NO. 2000-03

Shifting Effort - 75/90 (4-Stroke) Models

2000 75/90 (4-Stroke) USA 0G960500 thru 0T145221

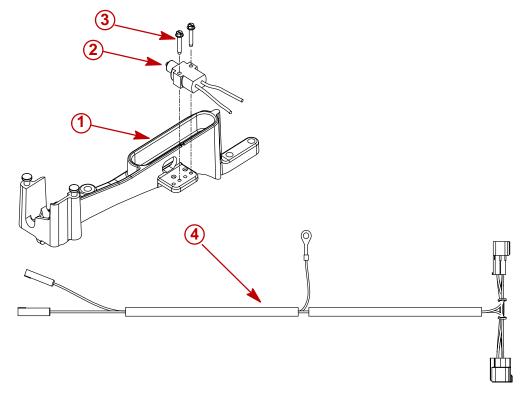
4. If the shifting effort continues to be excessive after performing the listed Preliminary Checks/Corrections, install a shift interrupt kit and complete a warranty claim as instructed.

1. Install Shift Interrupt Kit p/n 858793A6 as outlined in kit supplied installation instructions.

Ref.	Description	Qty.
1	Shift Link Bracket (858793A7)	1
2	Switch Assembly (87-813960A3)	1
3	Screw (10-824706-20) M3.5 x 20 mm	2
4	"T" Harness Assembly (84-878178A1)	1
